Corrected Comments on 10' setback on Civic Corridors in Eastern and Western Neighborhoods

To: Planning and Sustainability Commission
Chair Schultz:

Current Conditions on SE 122nd Ave. The Right of Way is 90 feet wide, with 6 foot sidewalks. (SE Hawthorne, for comparison, is 70' ROW)

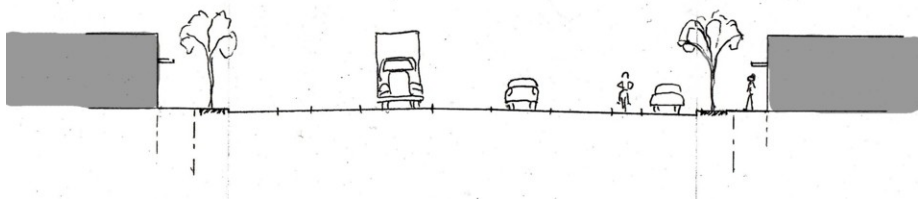
Building to building is **90 feet**.

As developed today. PBOT would require 6' dedications, to get 12' sidewalks

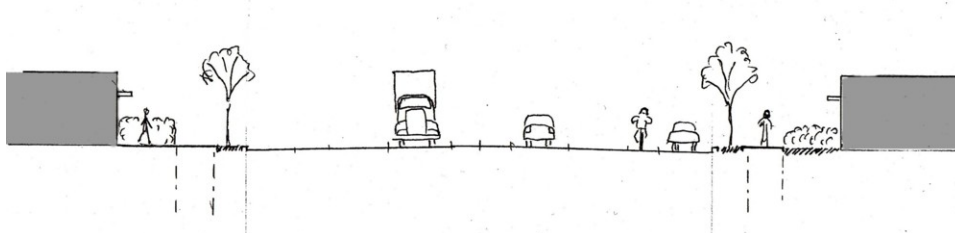
Building to building would be **102 feet**.

With current MUZ proposal, an additional 10' required setback beyond the 12' sidewalks

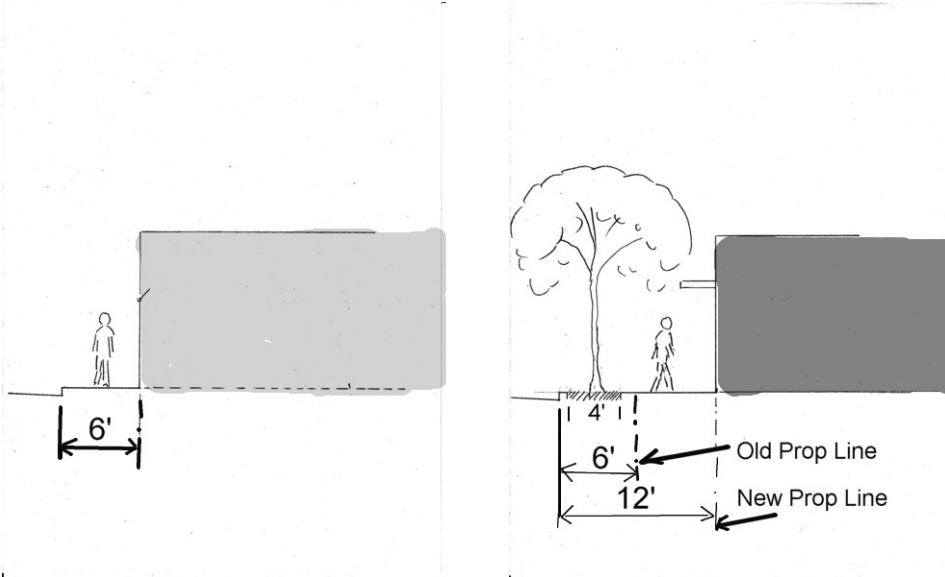
Building to Building would be **122 feet**. But is the pedestrian environment any better?

What the 10' MUZ setback would do; and my alternative: 9' dedication to get 15' walk

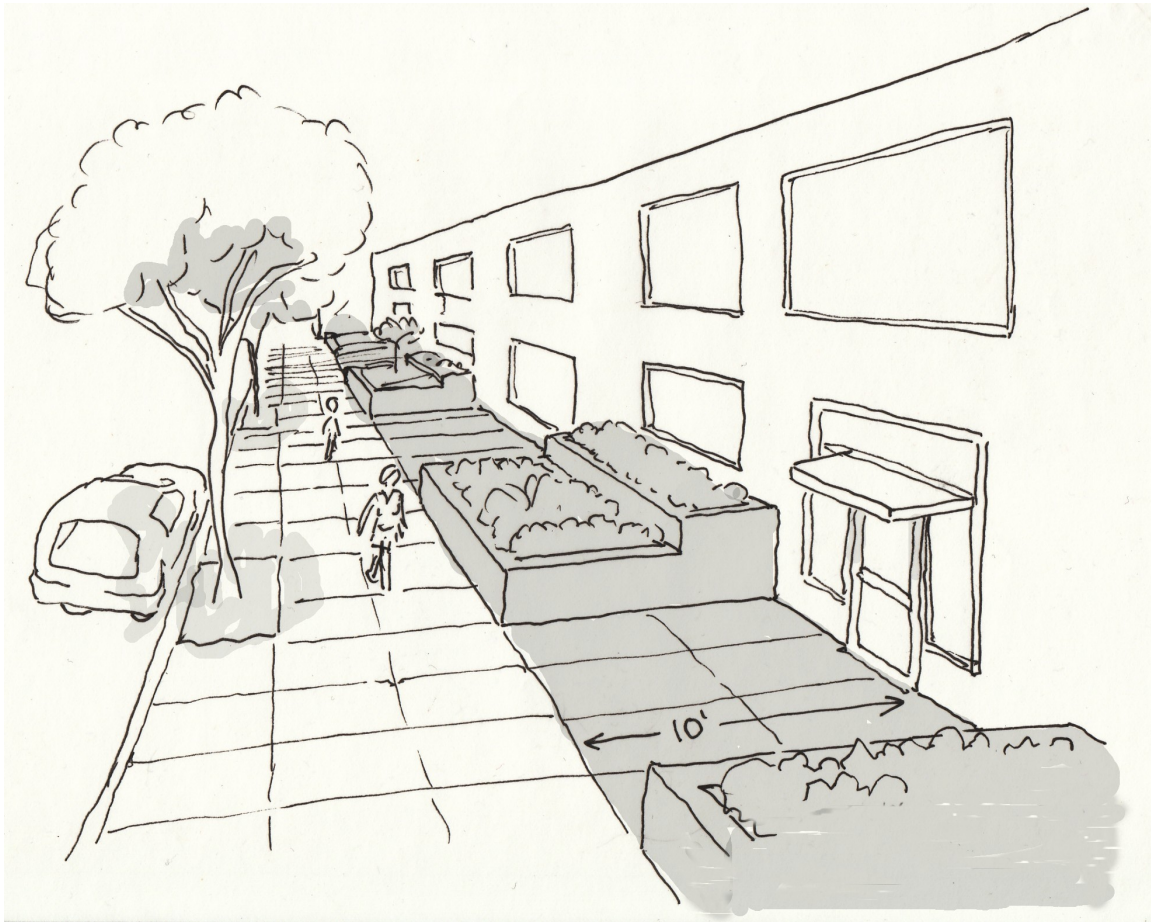
I agree with a required setback where there is residential on these streets. A 10' minimum for residential-only buildings would be alright. But I don't think the 10' additional space works well for retail and other commercial uses. The proposed code only requires 50% of it to be paved, so planters and other construction could occupy that space. So the result could be what I show below, which is not really a widening of the sidewalk. The public space would still be 12' wide. There would be additional private, perhaps unusable space between this public area and the building, isolating the building from pedestrians.

I believe the purposes of separating pedestrians from traffic and getting more green space can be satisfied by increasing PBOT's required dedication by just 3', so the public sidewalk will be 15' wide instead of 12', which allows a wider, 5' tree well, and bigger street trees. It could even include continuous planting strips near the curb. Admittedly, this would have to be implemented by PBOT.
